Date: October 30, 1997
 Refer to: EM/ER:97-438

**SUBJECT: RESPONSE TO REQUEST FOR SUPPLEMENTAL
 INFORMATION FOR THE CANYONS INVESTIGATION CORE
 WORK PLAN (FORMER OU 1049)**

**Request for Supplemental Information
Canyons Investigation Core Workplan**

Figure A-2. Current land use map for Operable Unit 1049.

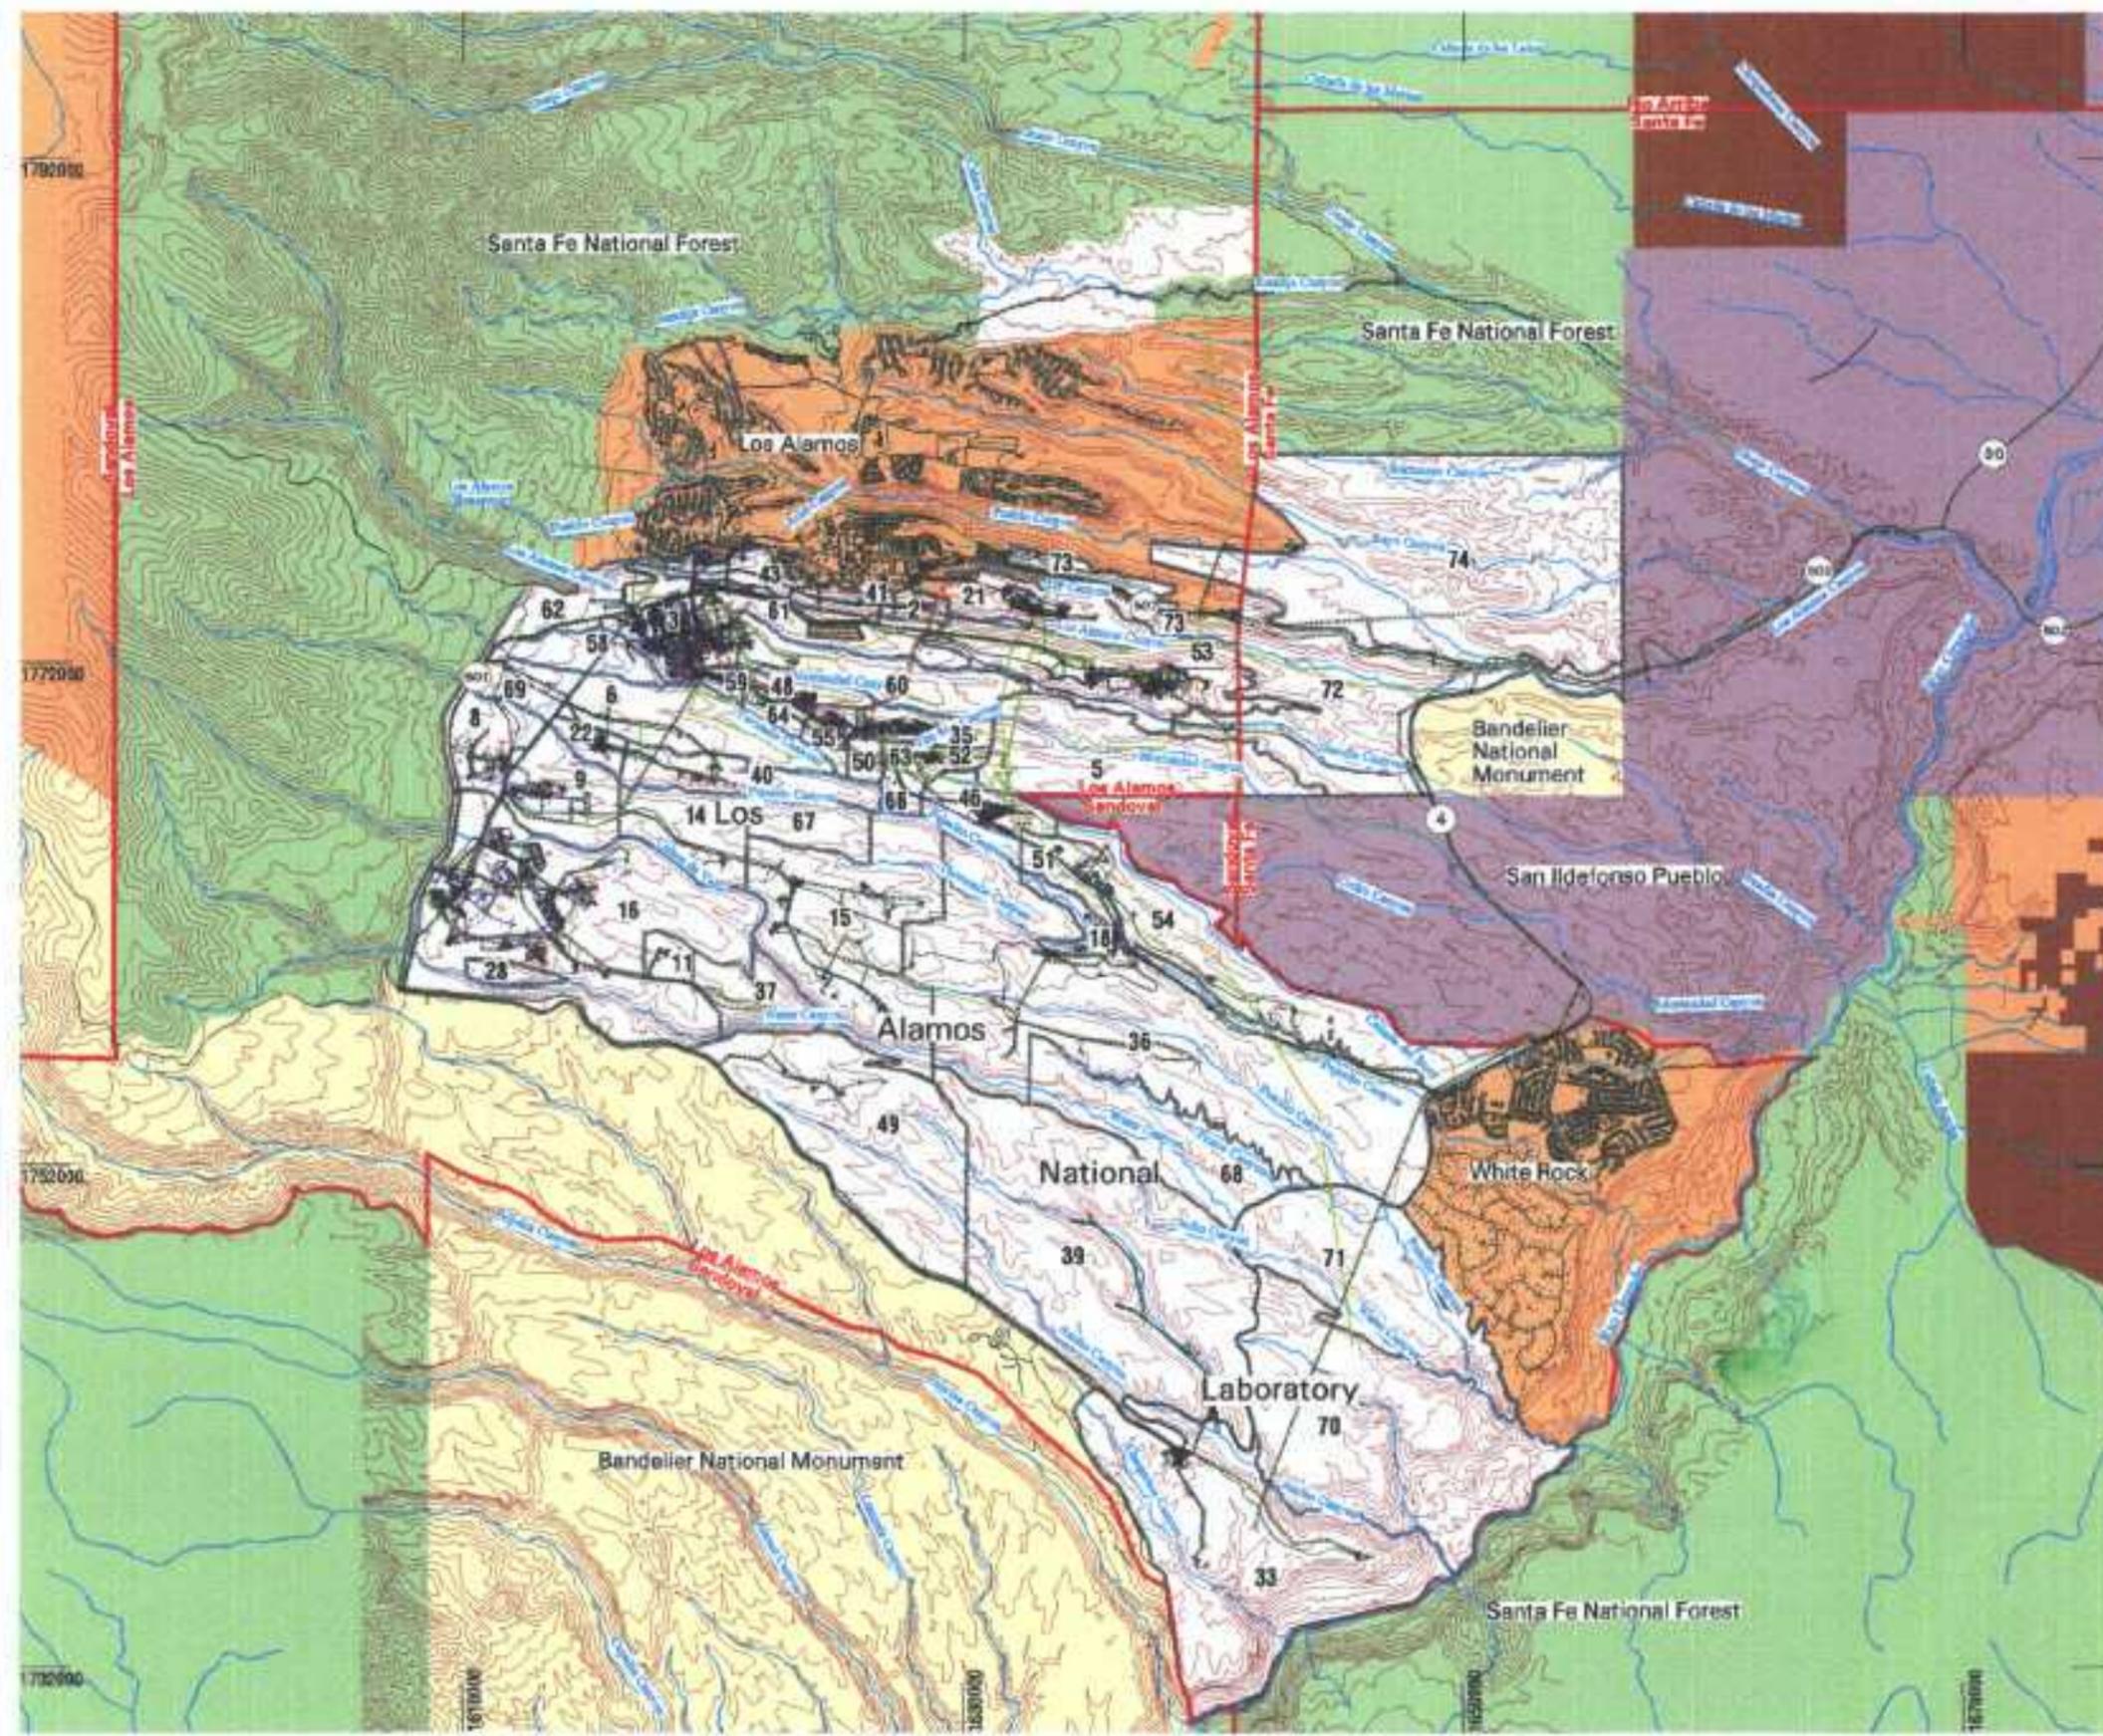
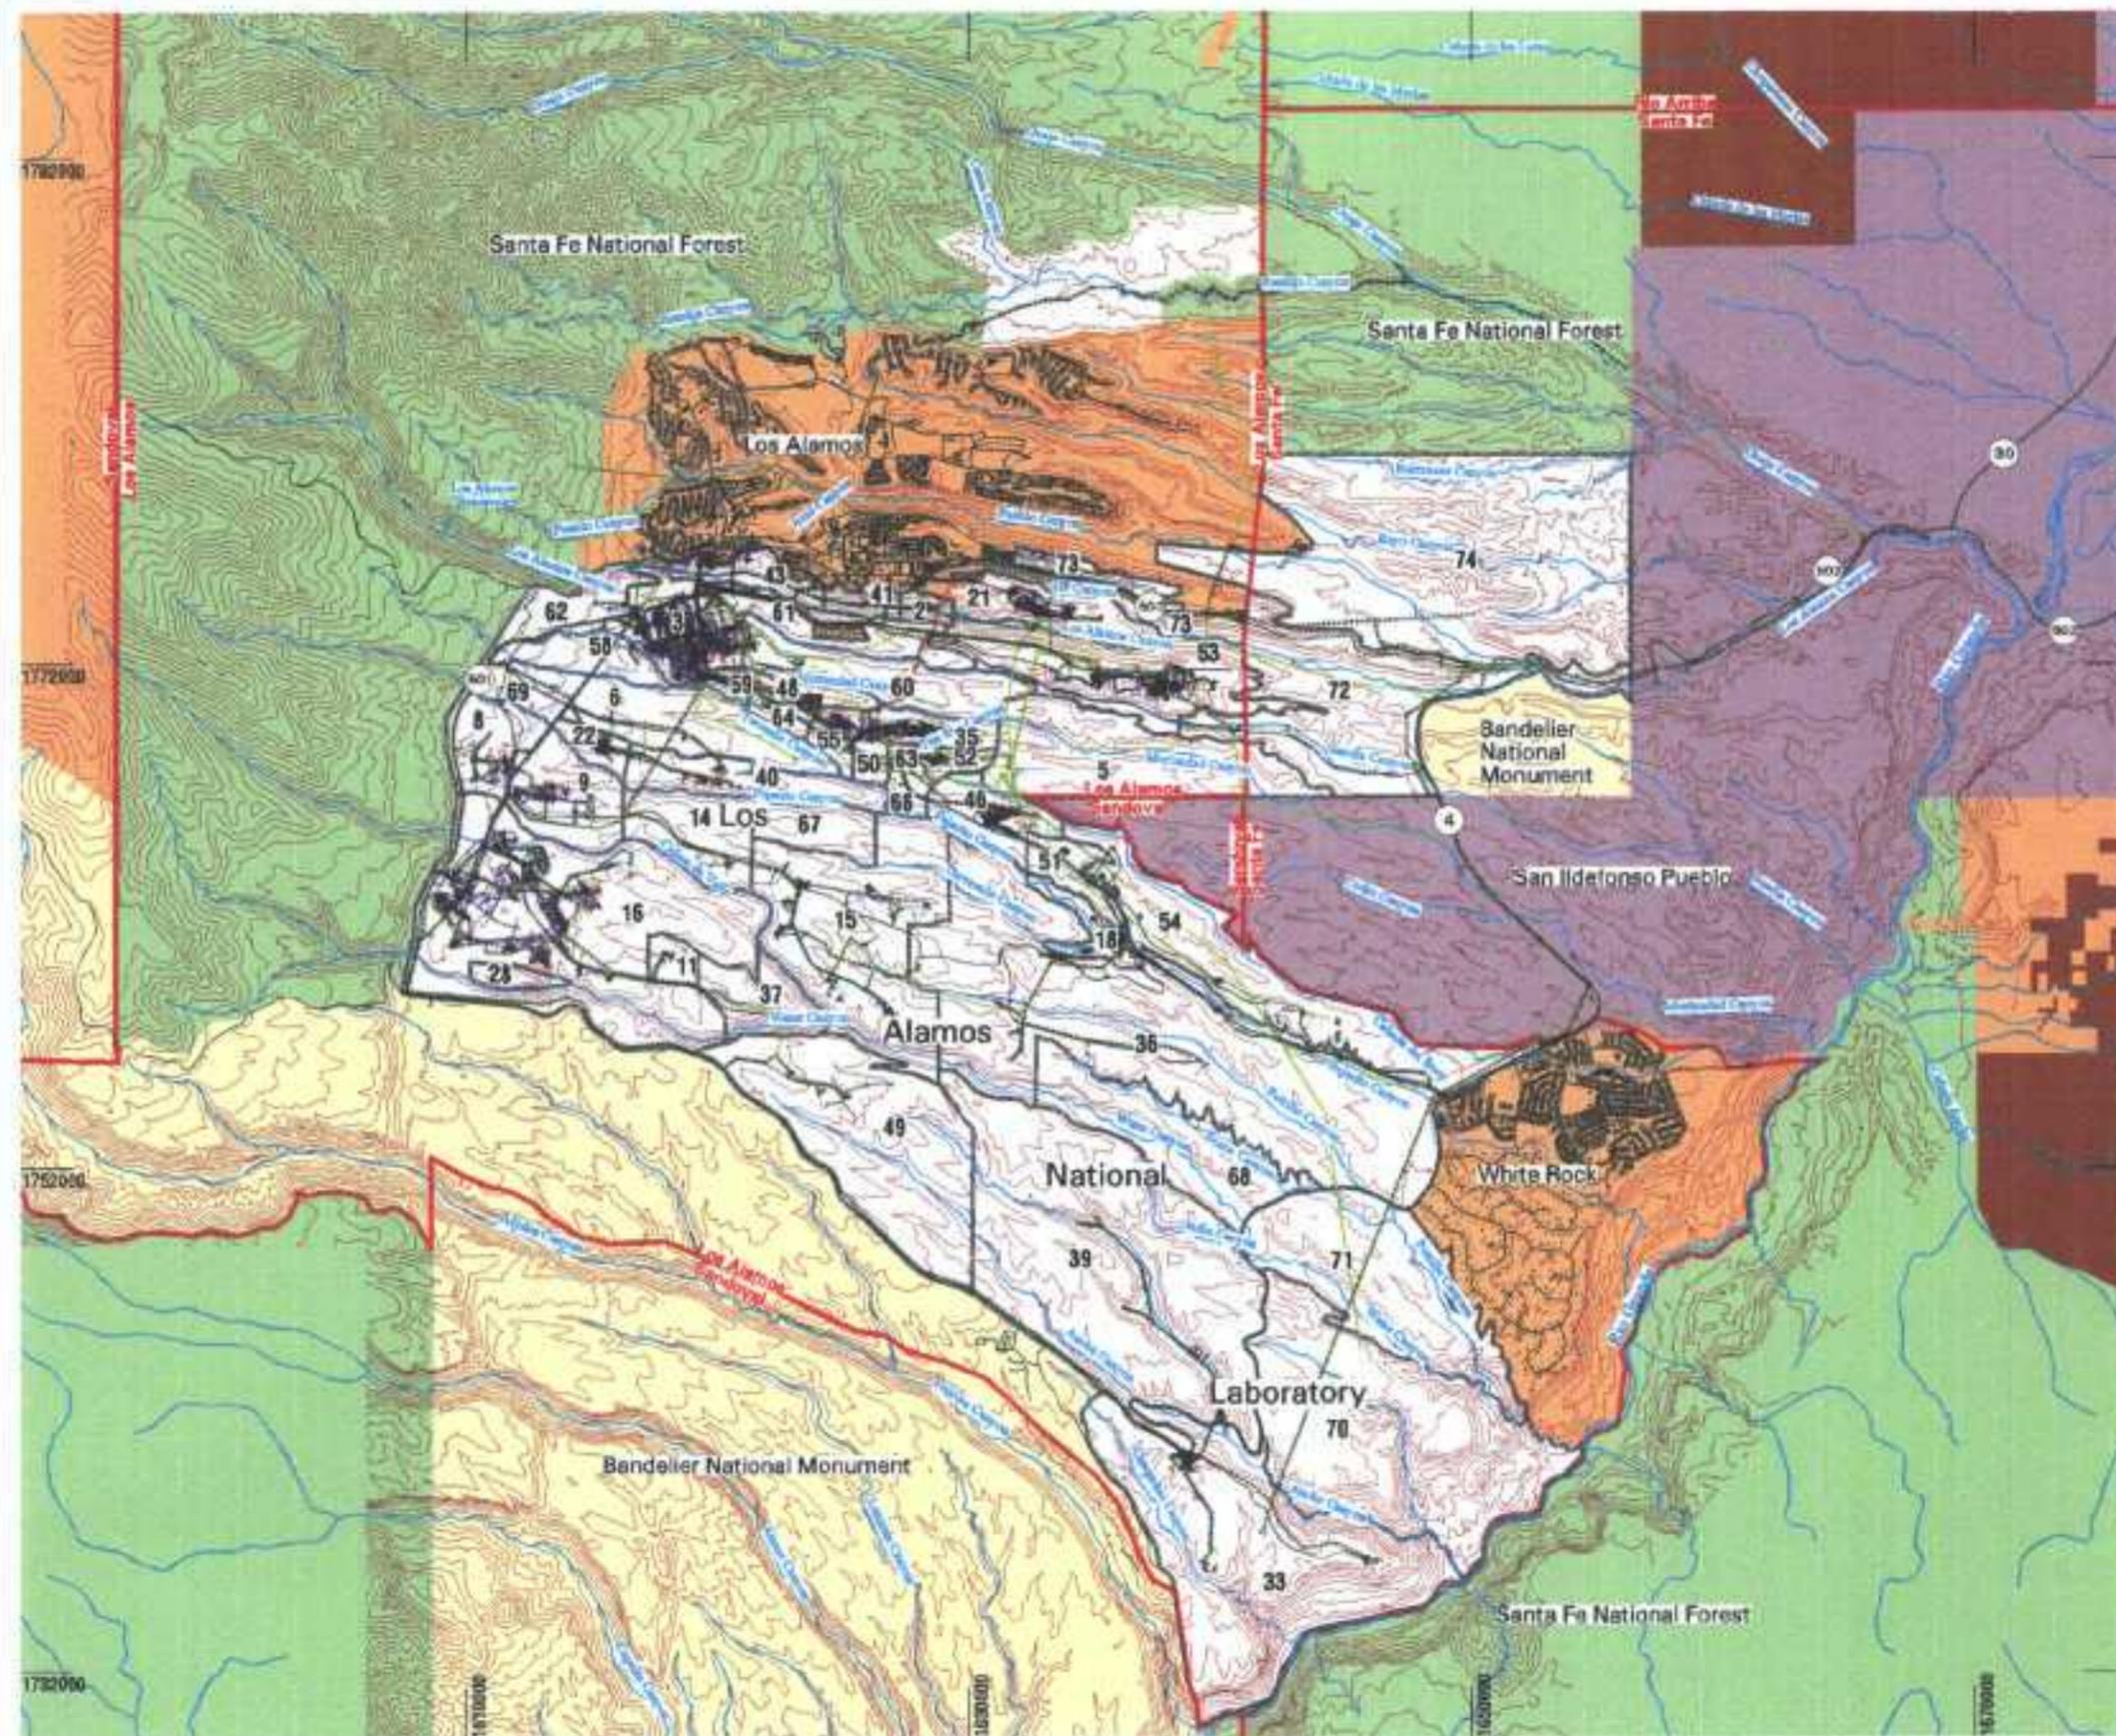
- a. *Figure A-2: Please revise this figure to indicate if it reflects current or projected land use.*

- a. Figure A-2 (copy attached) has been revised to indicate that it represents current land use.
